**Salem ODCM  
Rev 23**

# OFFSITE DOSE CALCULATION MANUAL

SALEM GENERATING STATION

Revision 23

FIGURE 5.1-3: AREA PLOT PLAN OF SITE

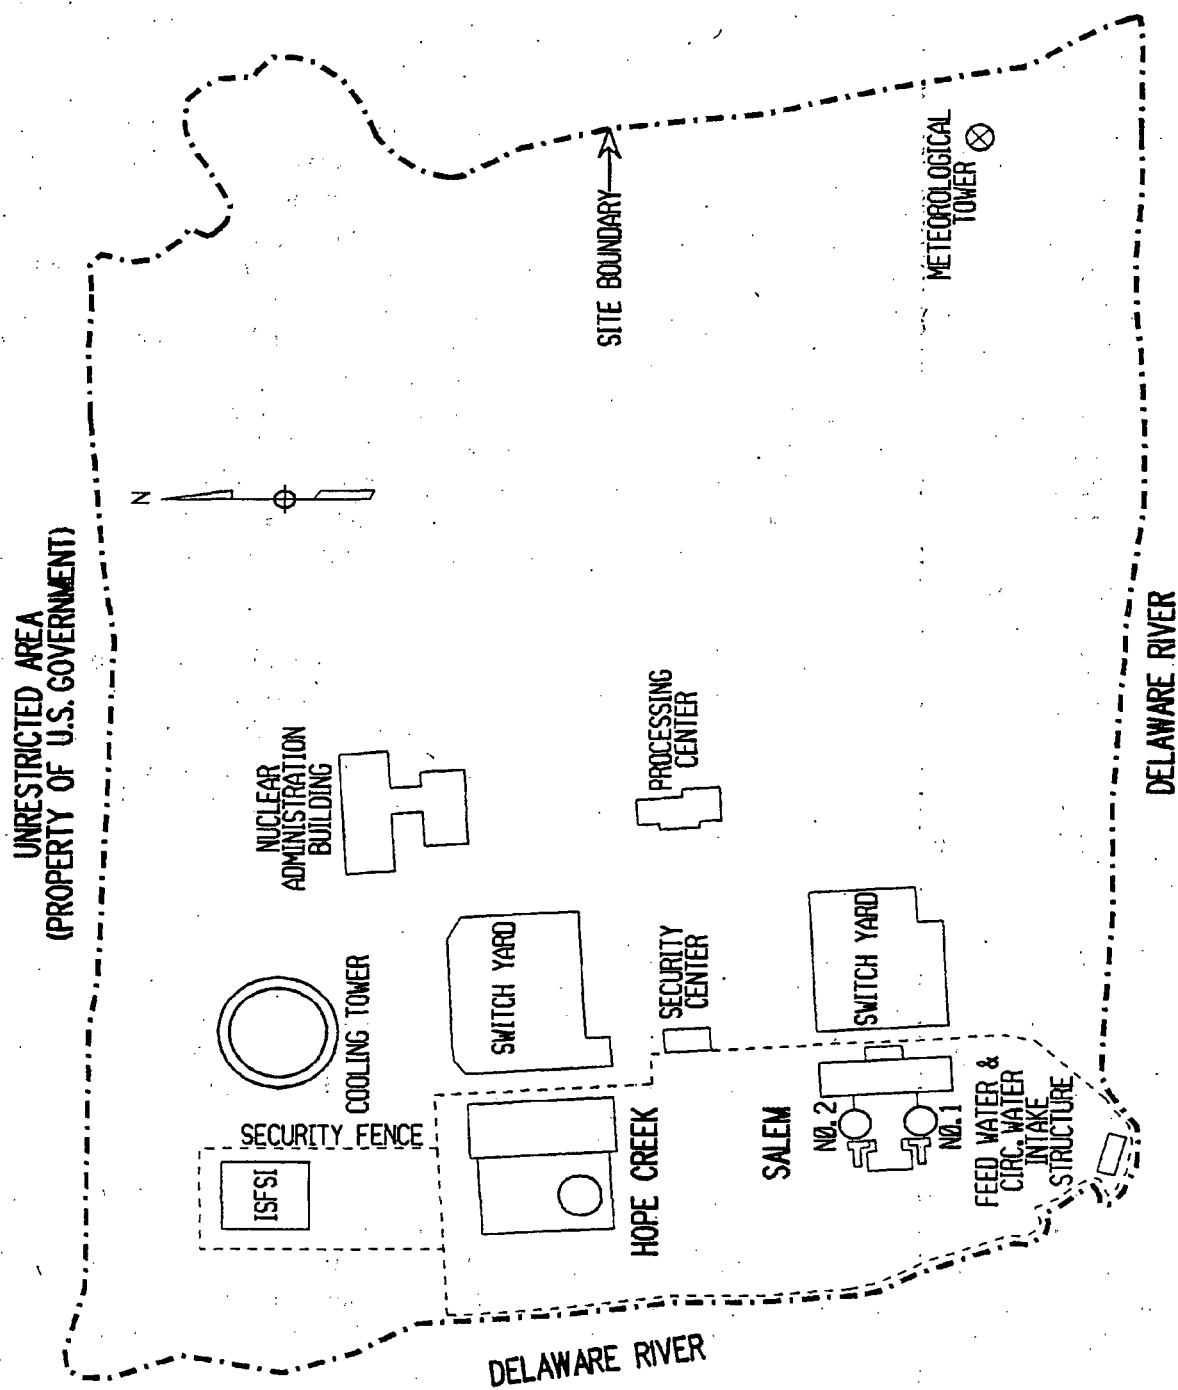
2. Revised the definition 1.29 for SITE BOUNDARY by adding the words "or property" after "land".

1.29 The SITE BOUNDARY shall be that line beyond which the land or property is not owned, leased, or otherwise controlled by the licensee, as shown in Figure 5.1-3.
